## ADDENDUM 3

### RFP: Project No. 6776 and 6777 Stormwater System

#### Replacement

**DATE OF ADDENDUM:** February 18, 2025

| Drawing No.<br><b>C202</b>           |

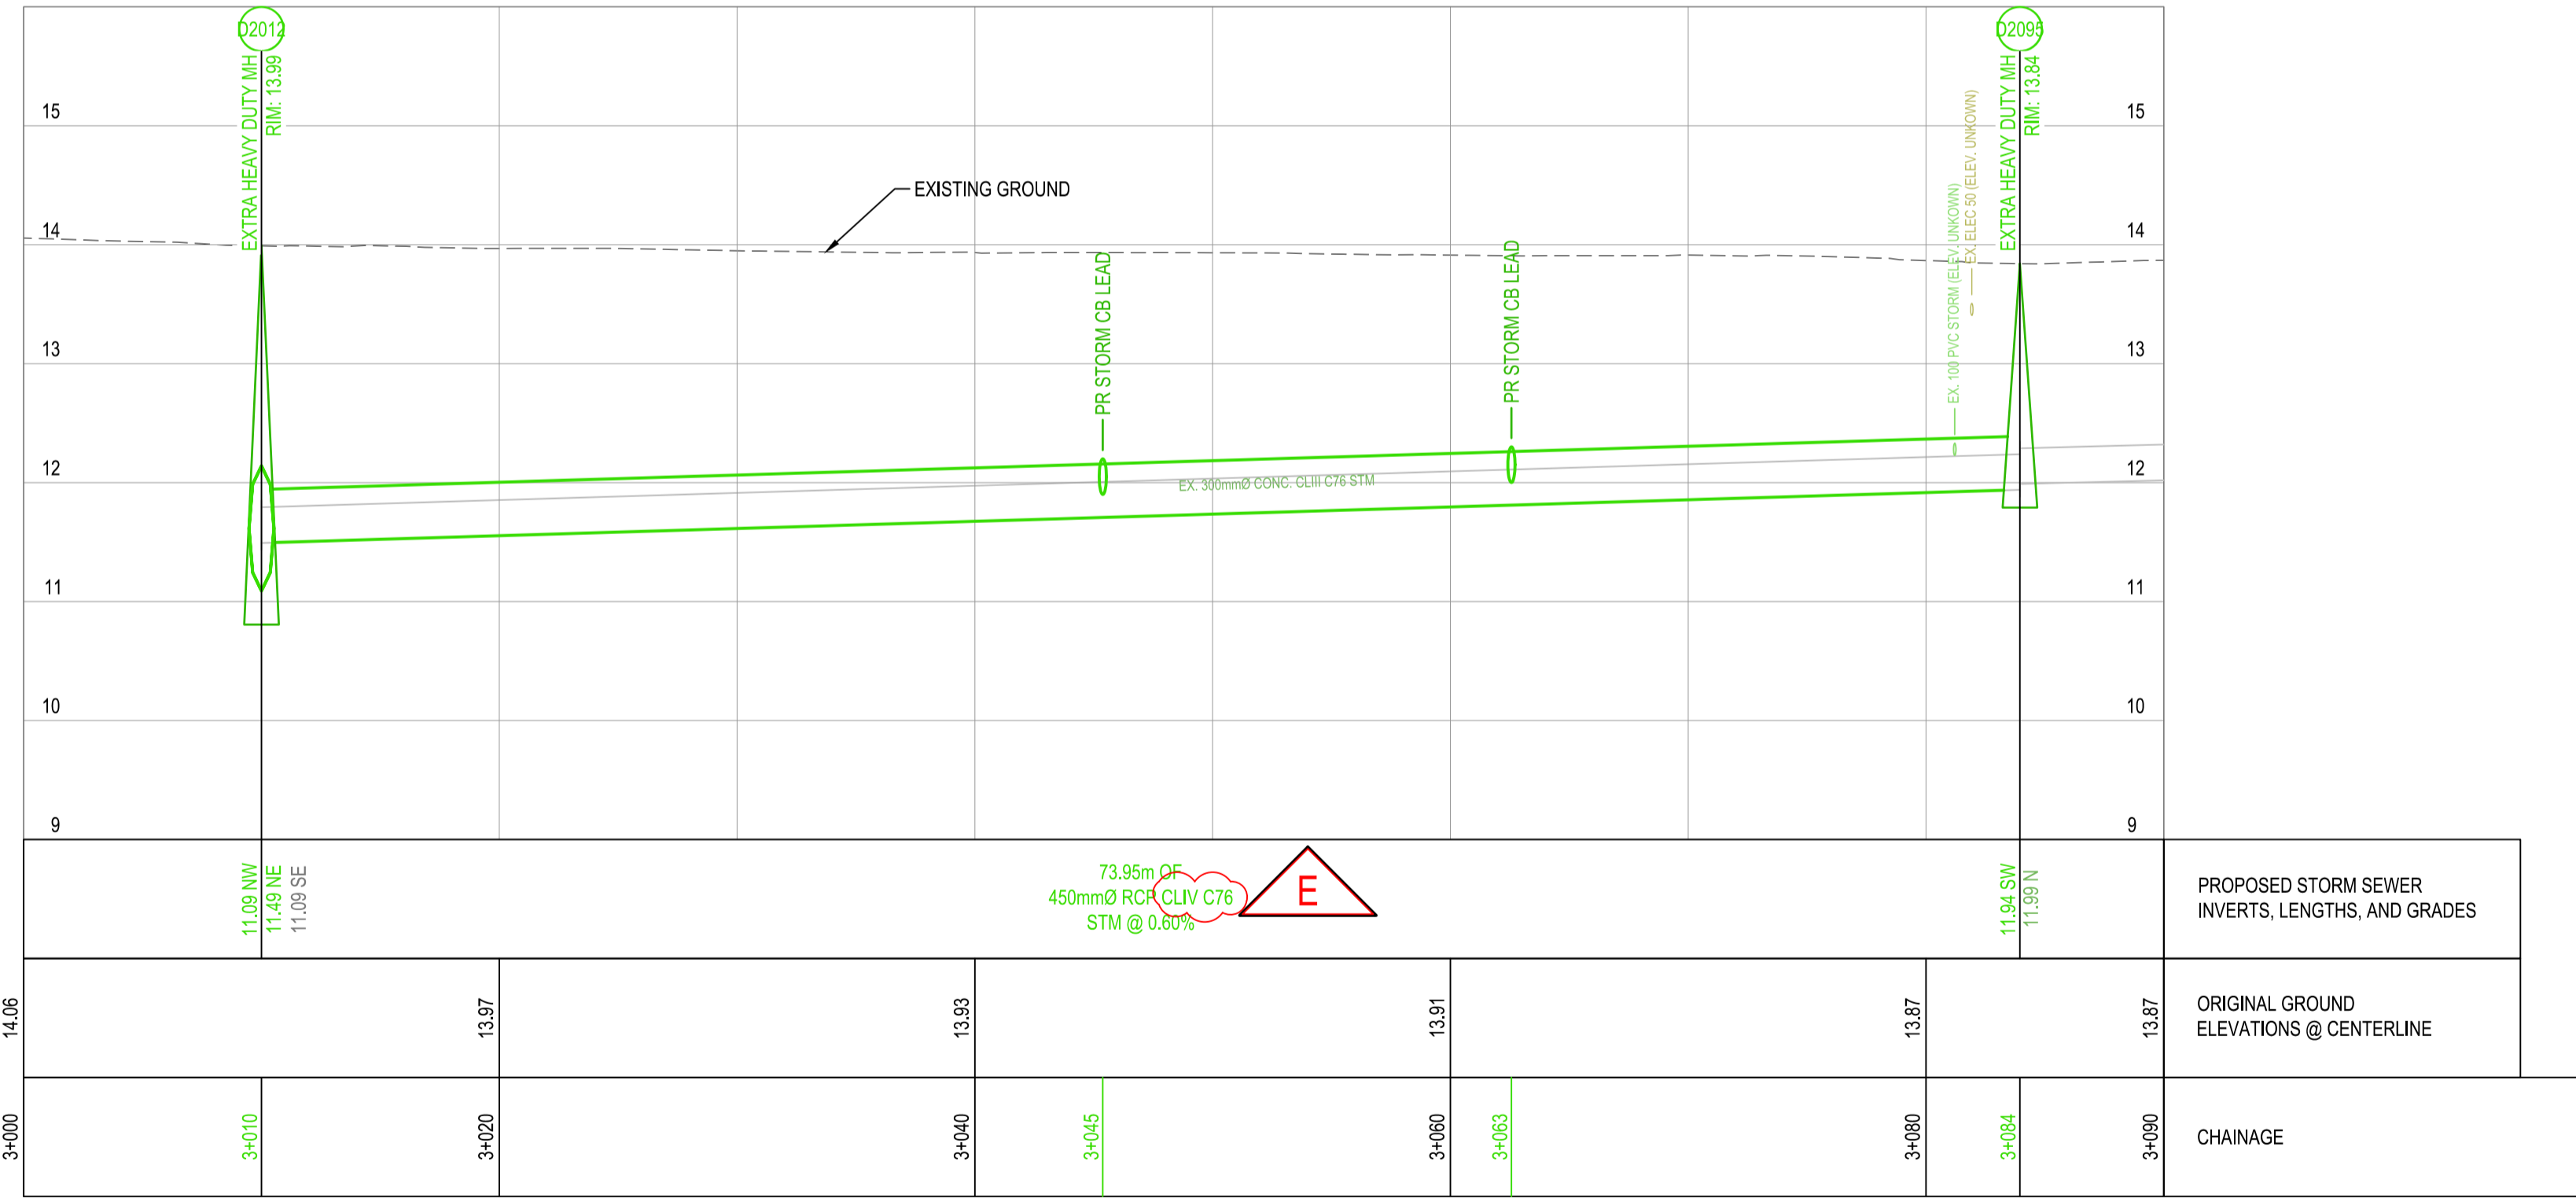
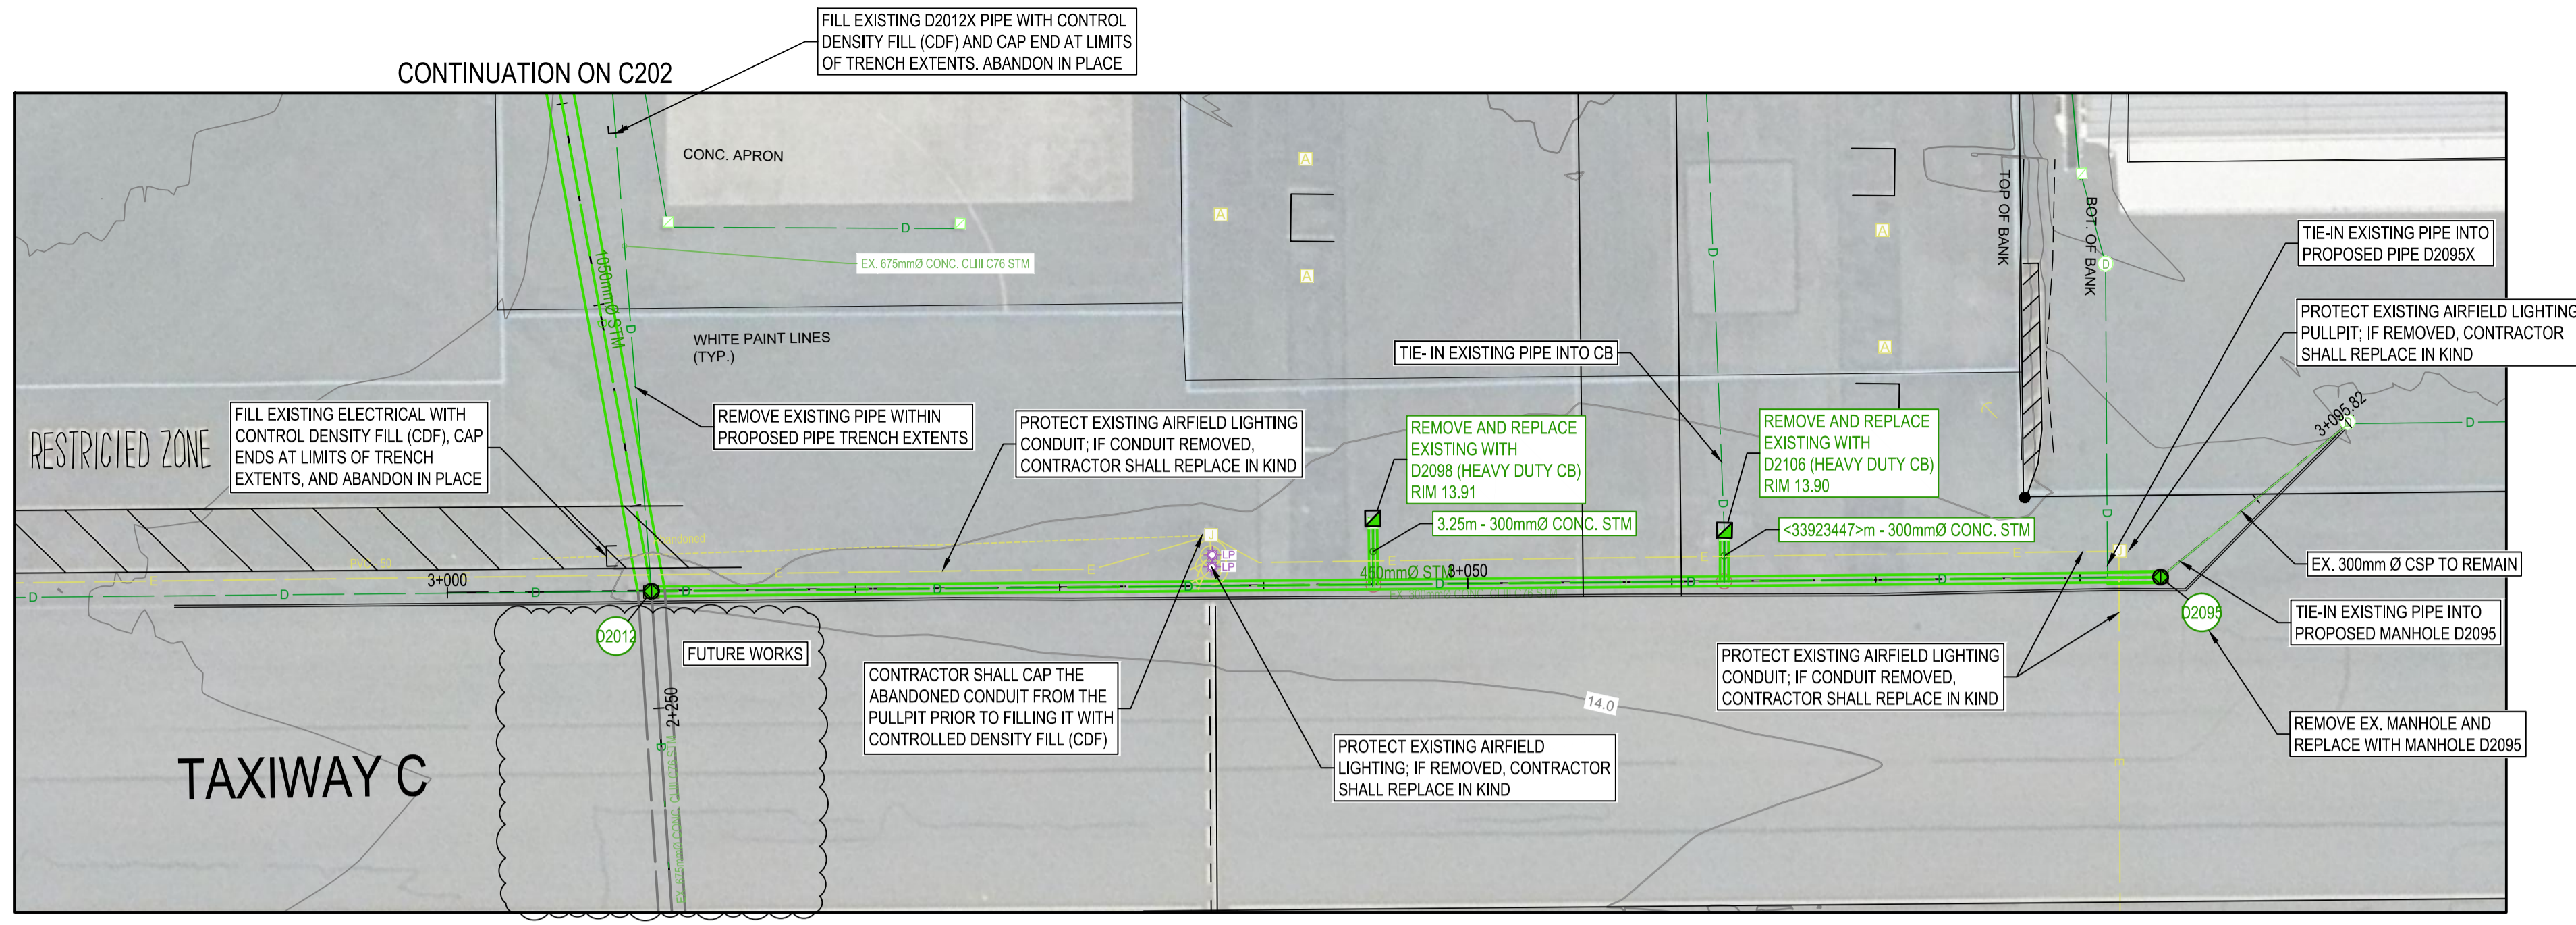
3. Q: Please refer to project 6777, sheet C202, Existing MH D2316 to Proposed manhole D2011 is connected by 250mm PVC. There does not appear to be a pay item for the 250mm PVC connection, please clarify how this will be paid.  
A: This is a typo. The pipe should be 300mm concrete as shown on project 6777, sheet C201. See revised 6777, sheet C202 Revision E under this addendum.

9. Q: For concrete storm pipes, please confirm ASTM C67 class 3 reinforced concrete pipes are acceptable to be used on this project.  
A: All pipes shall be Class III ASTM C76, except for the pipes on the airside. See the revised Form of Tender (FoT) Appendix 1 - Schedule of Quantities and Prices and C6777 Drawings C201 - C203.

- Project No. 6777 C201 (Rev E): Revised pipe material as response to Q9 above.
- Project No. 6777 C202 (Rev E): Revised pipe material as response to Q3 and Q9 above.
- Project No. 6777 C203 (Rev E): Revised pipe material as response to Q9 above.
- Project No. 6777 C502 (Rev E): Revised trench detail as responses to Q12 and Q13 above.

| Drawing No.           | C203          |

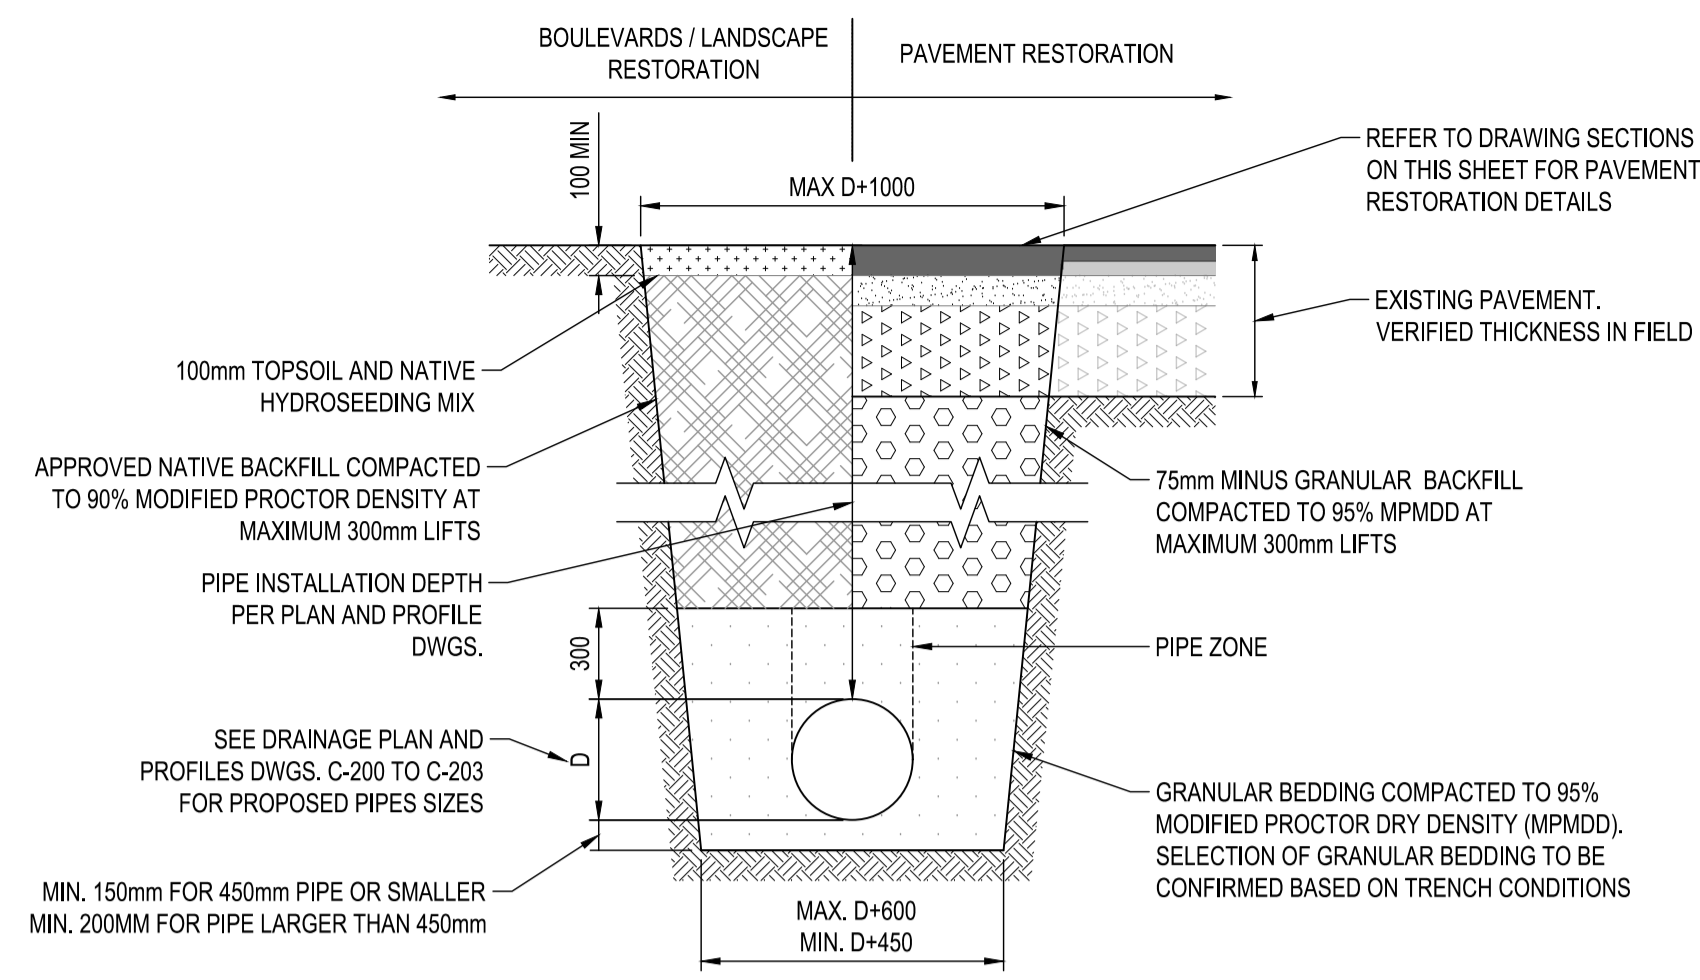
18. Q: Could you please provide a connection detail for the 300mm CB lead tying into the proposed 450 storm main on drawing C203?  
A: Successful contractor will submit connection details for the tie-in from 300mm and 450mm for review and approval. Prefabricated material can be proposed.

Drawing No.  
**C502**

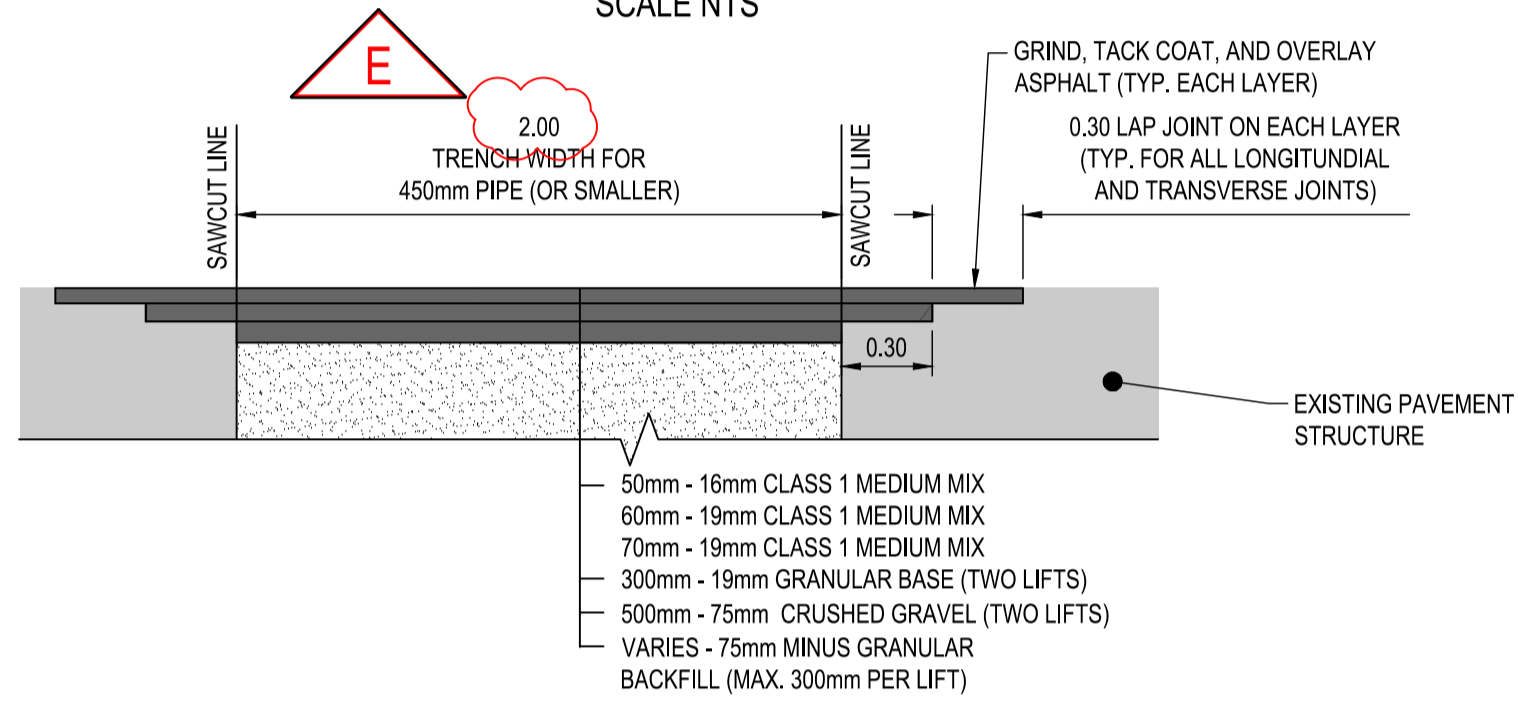
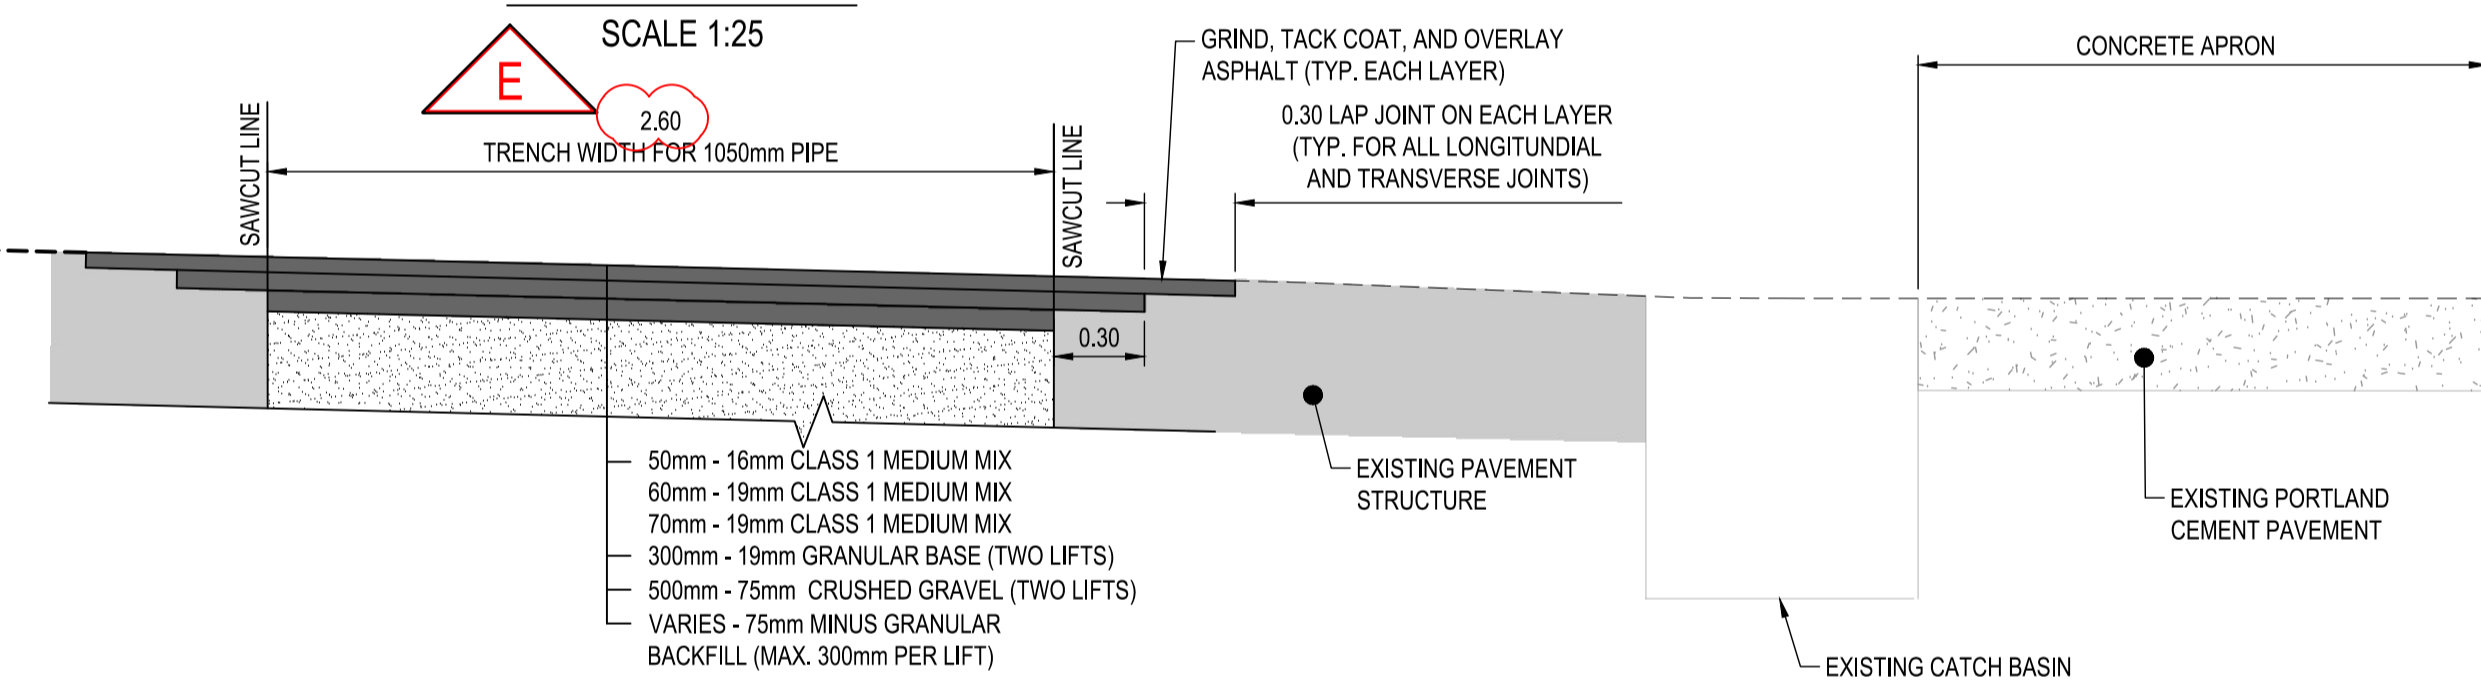
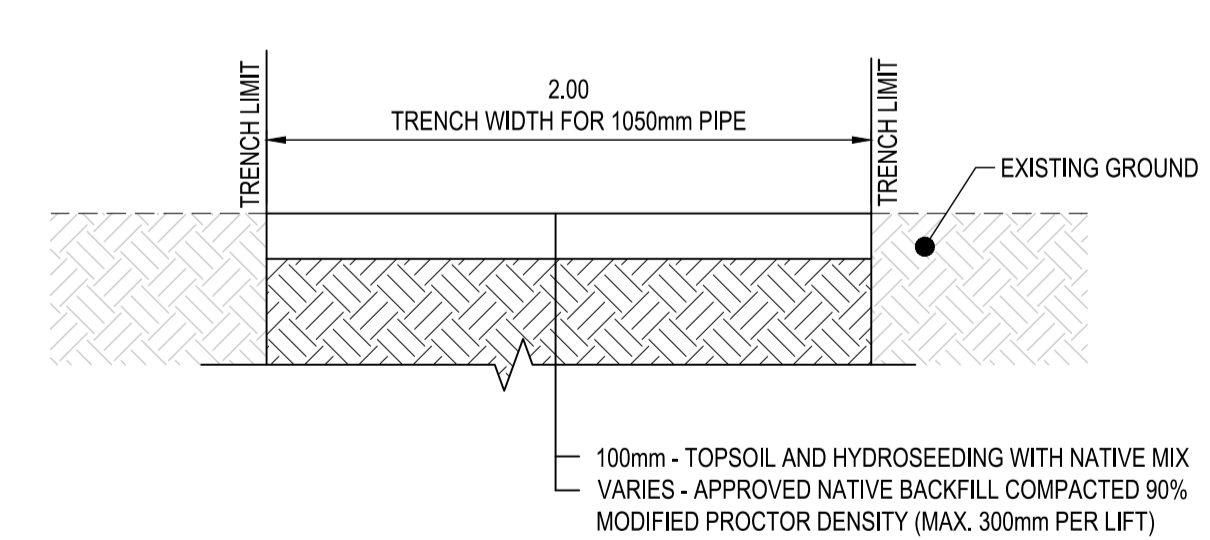
12. Q: The shoring trench excavation on 6777 Drawing C502 shows a width of 2m for the 1050mm. The pipe OD is 1.3m. Mechanical compaction equipment (Jumping Jack) will be required to compact the pipe bedding due to the pipe size with requires 0.45m of space between the cage wall and the pipe the trench cage walls are 0.1m thick each and there need to be 0.1m of space outside each cage wall so that the cage can be installed this is a total trench width of 2.6m not 2m. Do we have to factor in restoration beyond the 2m into our pipe price or will we be paid for the additional asphalt tonnage under the pavement restoration unit rates? In our experience with this size and type of pipe this is the minimum width that is achievable.

13. Q: This is the same as question 12 above but for the 450mm pipe trench restoration due to the same reasons as above in our experience the minimum trench width for 450mm concrete pipe is 2.0m not 1.2m, do we have to factor in restoration beyond the 1.2m into our pipe price, or will we be paid for the additional asphalt tonnage under the pavement restoration unit rates?

A: See Revised 6777 Drawing C502 and Form of Tender Appendix 1 Schedule of Quantities and Prices for the impacted quantities.

A: See Revised 6777 Drawing C502 and Form of Tender Appendix 1 Schedule of Quantities and Prices for impacted quantities.
